**F. Tavani and Associates, Inc.**  
*Traffic Engineering and Planning*

**RE: Villanova University  
Gilmore Letter dated 30 September 2014  
Radnor Township, Delaware County  
FTA Job # 211-027**

Reference: Villanova University – Lancaster Avenue Redevelopment  
CICD Conditional Use Transportation Review #1-*Revised*  
Radnor Township, Delaware County, PA

# LANCASTER / ITHAN

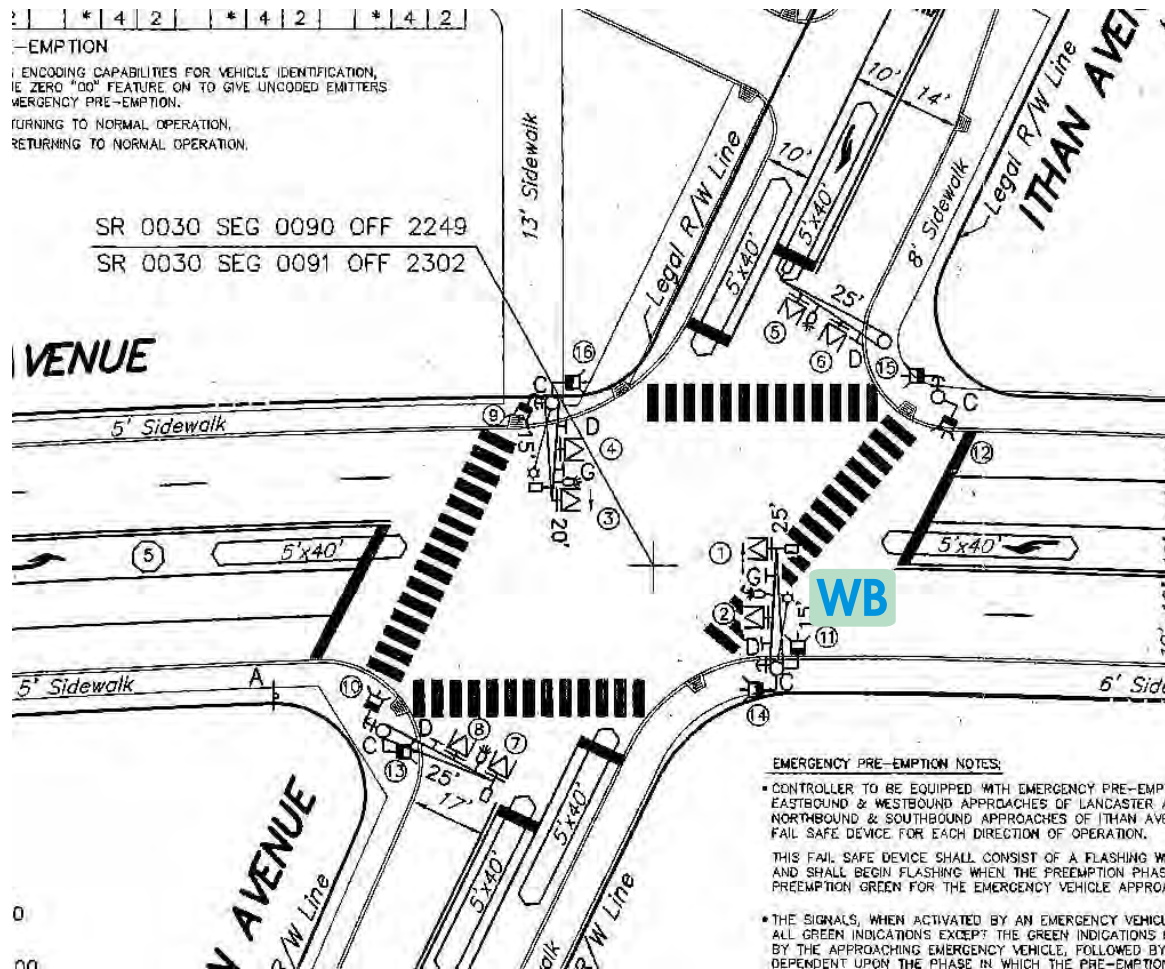
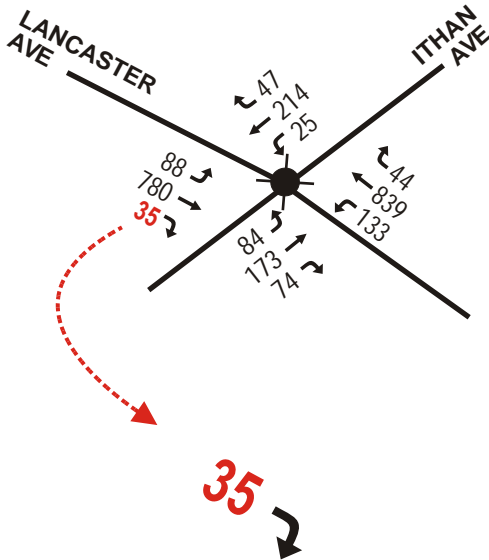
Township exhibits assert that current design guidelines will increase the ped phase duration. However, those exhibits also demonstrate some subjectivity (such as for the 'Walk' time) and earlier requests by RETTEW to reduce crosswalk lengths are also yet-to-be fully explored (and may result in reduced pedestrian phase duration).

For example, there may be an opportunity to realign the EB crosswalk as depicted below. Since the length of the EB crosswalk has a direct relationship with the ped phase duration, the realignment could result in reduced ped phase duration. However and as previously mentioned, adding a new right-turn lane will increase the length of the EB crosswalk, and so would increase the duration of the pedestrian phase.

The duration of the existing ped phase can be maintained and possibly even shortened provided no new EB right turn lane is introduced.

### PM Peak Hour

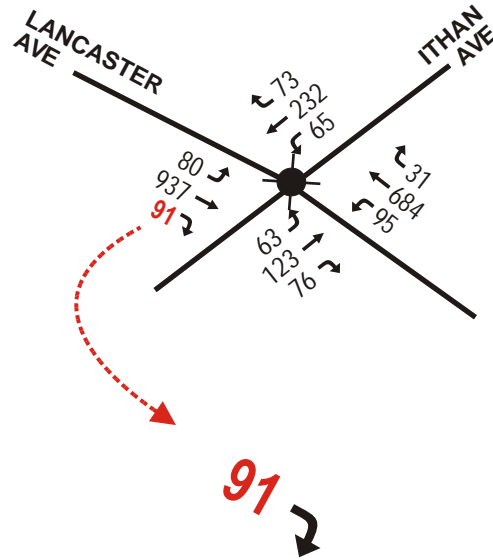
**91 vehicles per hour** make a right turn under existing conditions during the PM peak hour.

# 2023 Projected Conditions Weekday PM Peak Hour Traffic Volumes

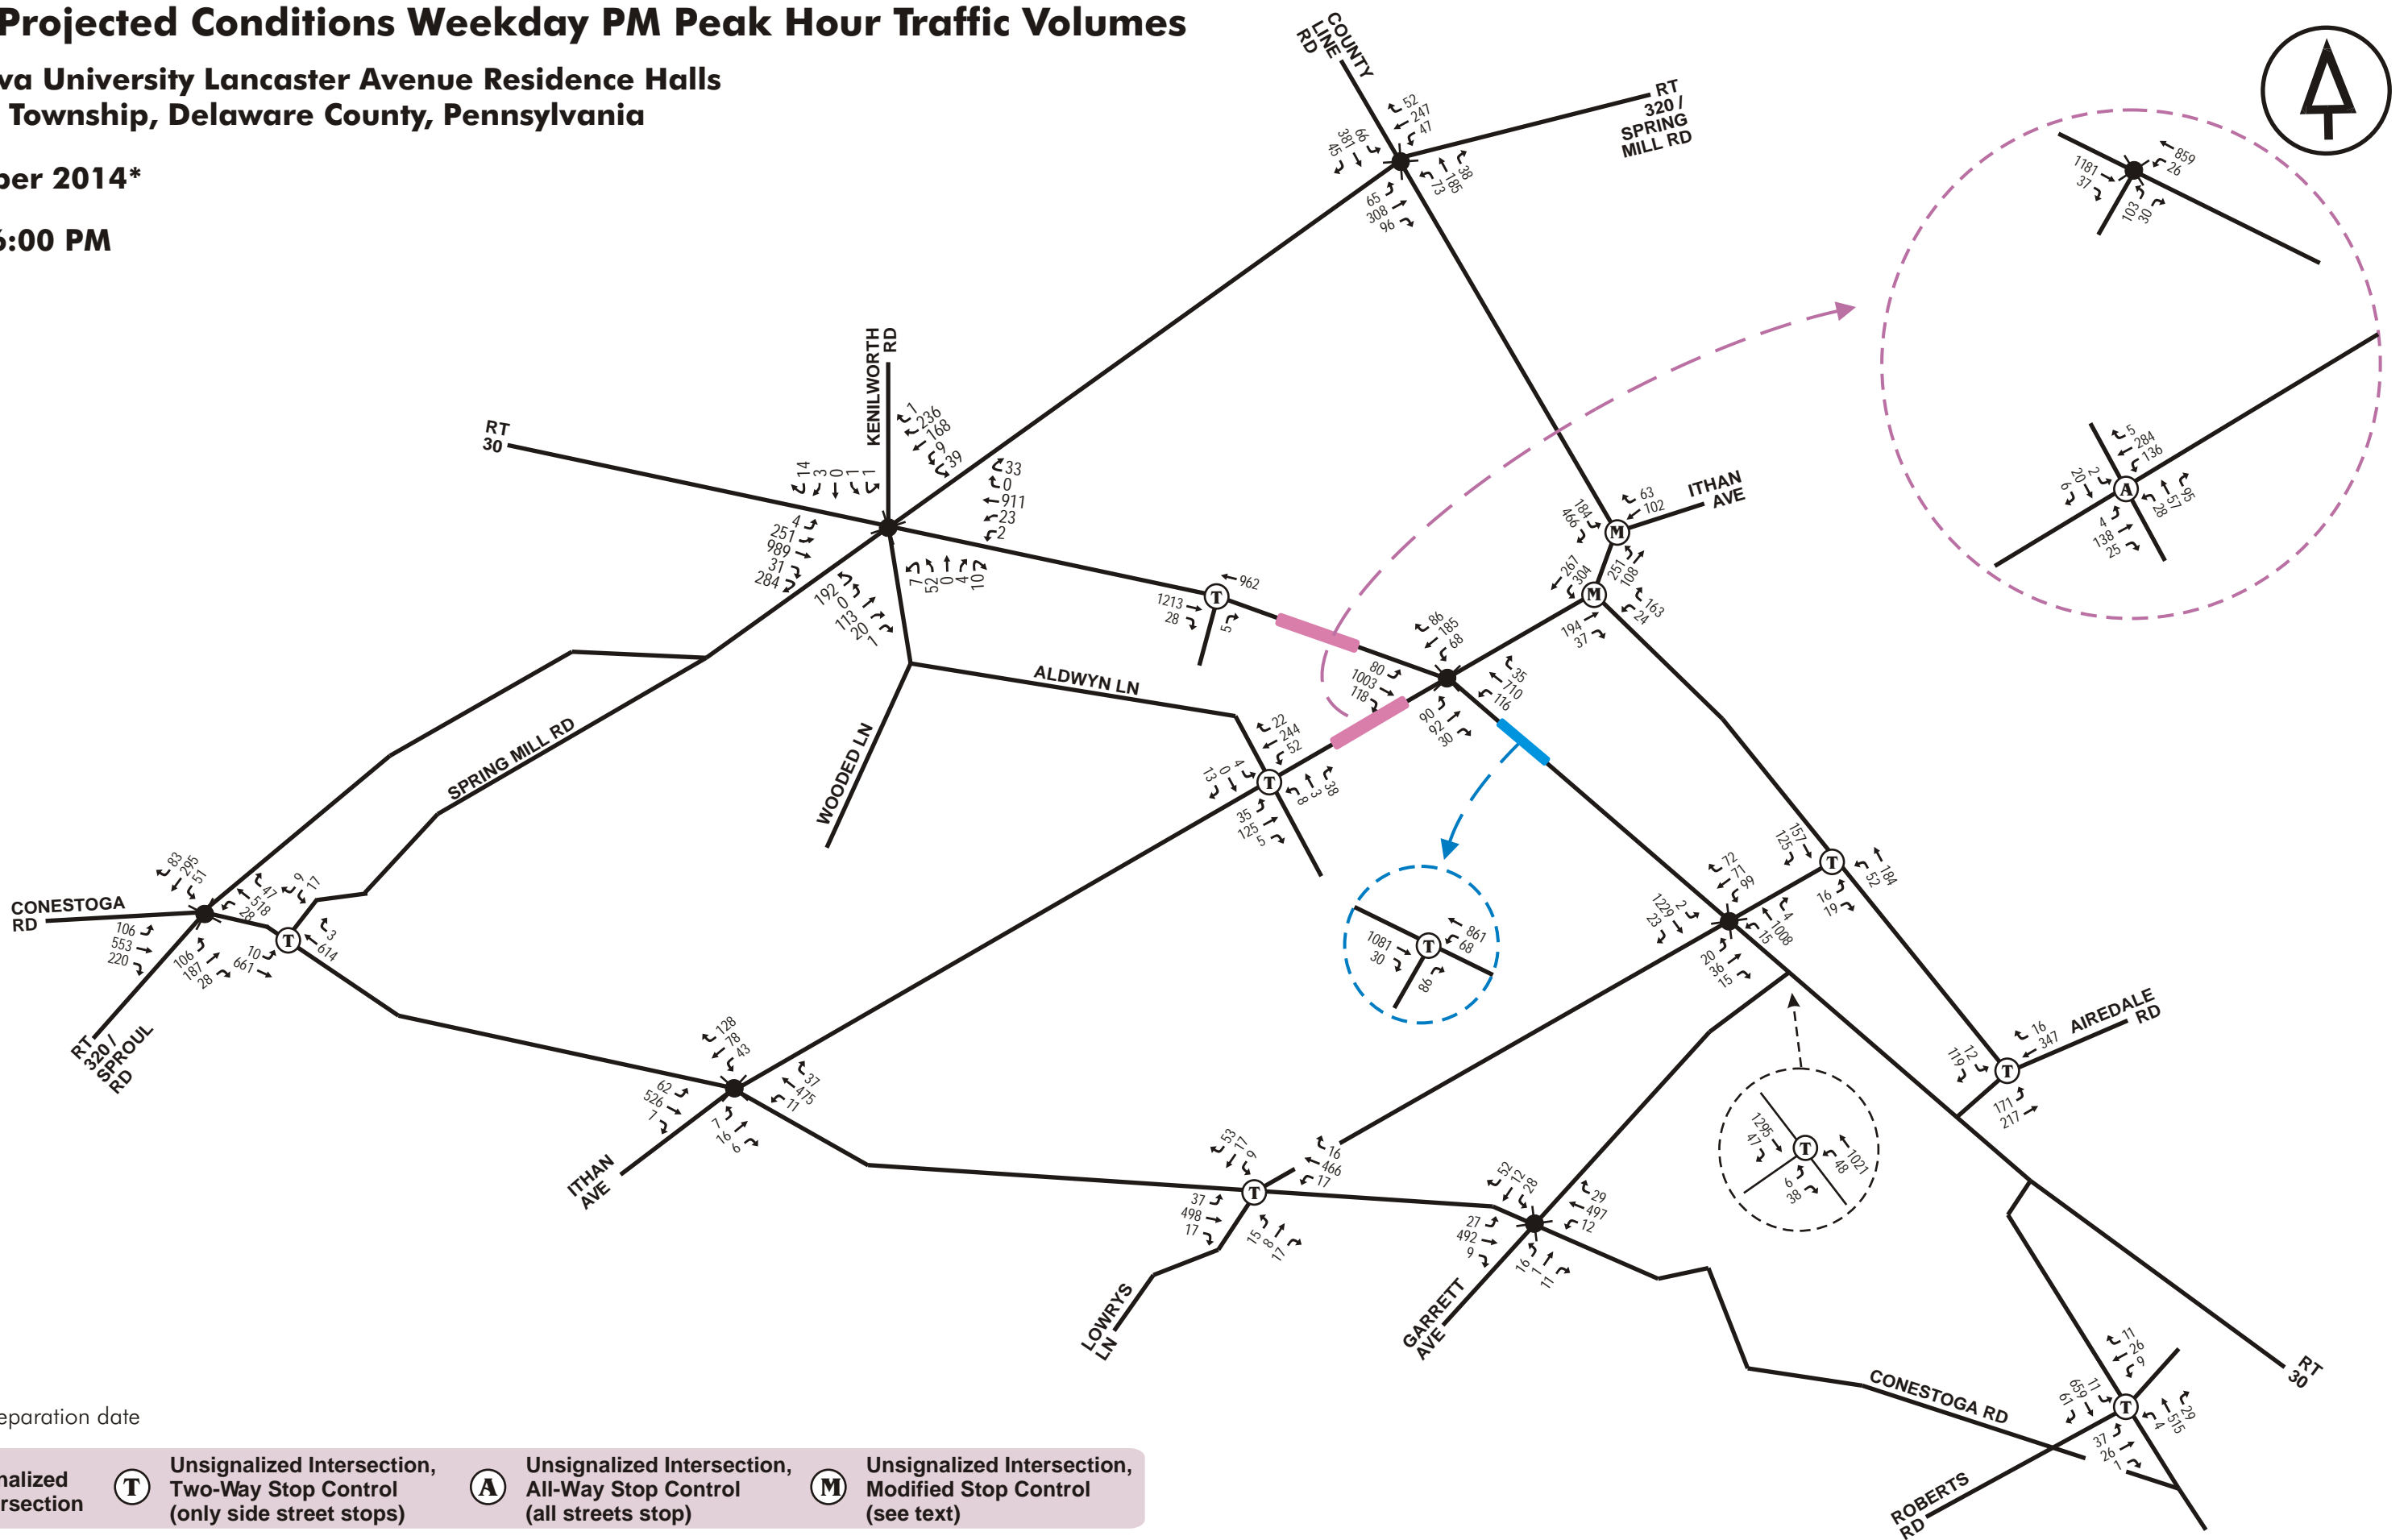
- J. Verify the 2023 PM Peak Hour traffic volumes for the eastbound right turn lane at the intersection of Lancaster Avenue and Ithan Avenue and revise as needed. It appears the PM Peak Hour 2023 traffic volumes are less than the existing conditions and the 2018 conditions; verify and revise as necessary.

- K. There are some inconsistencies between the 2014 figure volumes and the analysis. These inconsistencies should be corrected.
- L. The applicant indicates an eastbound right-turn lane at the intersection of Lancaster Avenue and Ithan Avenue would have limited value during ordinary traffic conditions and would be insignificant during special events. No analysis was provided for this conclusion. The report must include a right turn lane warrant analysis based on PennDOT Publication 46 Traffic Engineering Handbook. During special events, a right turn lane will provide relief for the congested eastbound through movement and if a right turn is not provided, it is anticipated the two eastbound lanes will operate as one though lane and a de facto right turn lane thus reducing the capacity of Lancaster Avenue. To improve the operation of the intersection and to better accommodate special event traffic, an eastbound right-turn should be provided.

**The noted inconsistencies were found and addressed. See also response to “F”.**

**The noted inconsistencies were found and addressed. See also response to “F”.**

- *Item F* – Synchro evidence regarding the intersection of Church Walk / Route 30.
- *Item J* – A corrected version of Figure 14 (note that while Figure 14 contained errors, all of the Synchro worksheets from the September 2014 TIS reflected the correct volumes).
